And A requested change to the Central Otago District Council's
Operative District Plan – Plan Change 13 (PC13)

STATEMENT OF EVIDENCE OF ANDY CARR for

River Terrace Developments Limited

Dated 22 April 2019

Figure 1: Routes Affected by Sealing of Sandflat Road

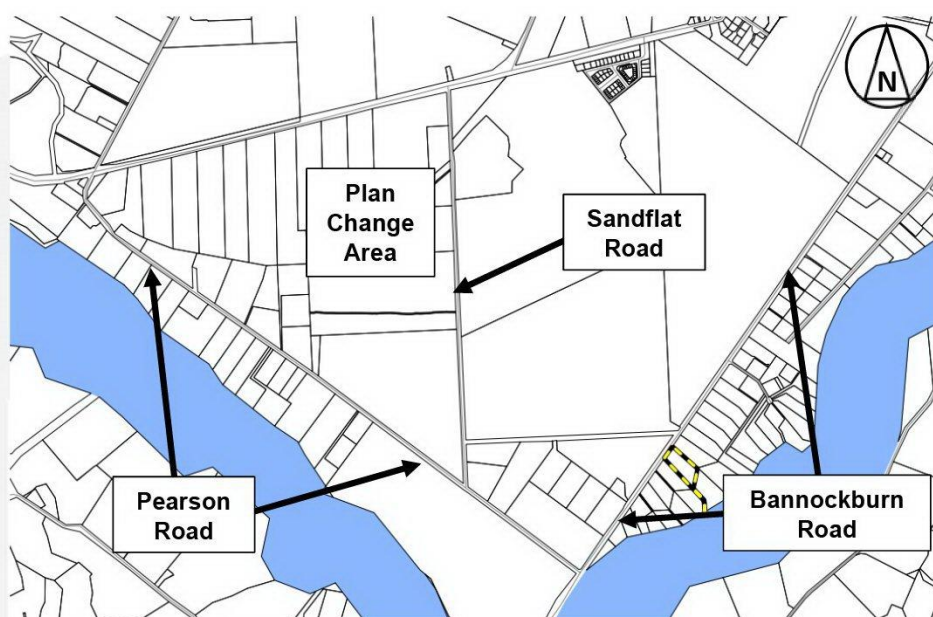
2.1. Stantec Comment: Scope of Assessment

2.2.1. The Transportation Assessment considered the use of district roads (paragraphs 6.2.4 and 6.2.5) and determined that vehicle movements would be likely to be via SH6 on the basis that the highway provided the shortest route to key destinations. This was supported by timed runs which had the same outcome, of travel via SH6 being the faster option in each case. There is/was also likely to be an effect on trip distribution associated with drivers choosing to avoid the unsealed section of Sandflat Road south of the plan change area.

2.2.2. Since the plan change request was lodged, it has been confirmed that as part of the plan change provisions, the whole of Sandflat Road will be sealed. This will reduce the journey times for drivers using the southern part of the road and remove any effects associated with drivers seeking to avoid the unsealed road, and therefore means that the routes towards the south (Pearson Road and Bannockburn Road) will become more attractive.

2.2.3. Overall, we consider that the roads which may be affected by the redistribution of the plan change traffic are Pearson Road and Bannockburn Road.

2.2.4. Even allowing for the route via Sandflat Road (south) to be faster than at present, it will remain the longer route in most cases and therefore will not be the route taken by the majority of traffic. We address this in more detail later, when considering traffic distribution.

Figure 4: Existing and Future Walking and Cycling Infrastructure

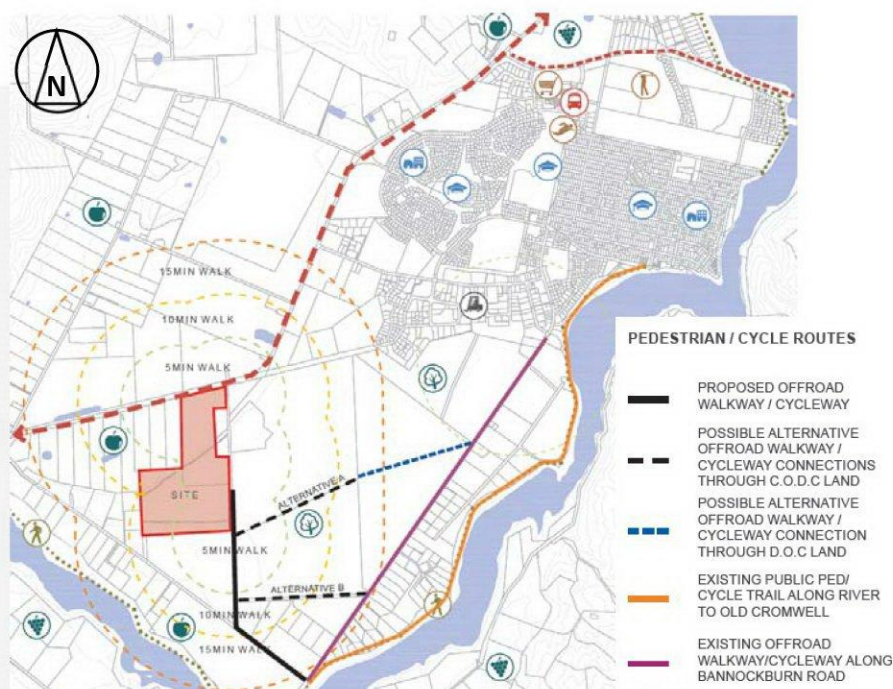
2.5. **Stantec Comment: Non-Car Modes of Travel**

2.6.1. We attach below a plan showing the extent of existing and proposed provision.

2.6.2. The plan change provisions now include for an off-road route running along Sandflat Road and Pearson Road to connect to the existing route on the southern side of Bannockburn Road.

Figure 5: Roading Network Towards West (Plan Change Area Superimposed)

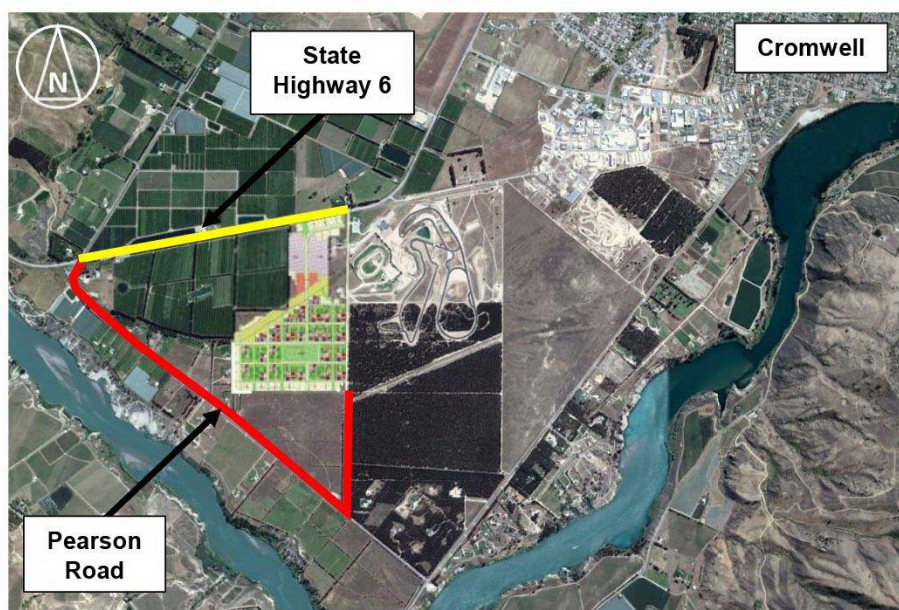
- 6.1.9. As many of the movements made to and from the development will not be related to commuting, and there are likely to be a higher number than assessed to and from Cromwell, it is considered a more comprehensive assessment of the sensitivity to the use of local roads is necessary. That should include matters such as safety, and potential change in function of different roads.

- 6.1.10. For example, if the volume travelling to and from Cromwell is closer to say 70%, that represents over 4,000vpd to/from Cromwell, of which at least some will travel via the local road network. As indicated by the existing traffic volumes which are low on adjacent rural roads, even a small portion of the 4,000vpd could result in the need for modifications to the road design and provision for other transport modes. By not upgrading the connection via Sandflat Road and Pearson Road through to Bannockburn Road, there is very little resilience in the transport network.

6.2.11. Towards the west, the two options are via Pearson Road and via SH6.

- Southern edge of plan change area to SH6 / Pearson Road intersection, via Pearson Road: 2:29 minutes;
- Southern edge of plan change area to SH6 / Pearson Road intersection, via SH6: 2:26 minutes;
- Northern edge of plan change area to SH6 / Pearson Road intersection, via Pearson Road: 3:32 minutes; and
- Northern edge of plan change area to SH6 / Pearson Road intersection, via SH6: 1:23 minutes.

6.2.13. Allowing for the sealing of Sandflat Road and therefore a faster travel time, we consider that the properties served by the southernmost of the east-west routes within the plan change area will use Pearson Road with the remainder using SH6. This equates to around 15% of the plan change area.
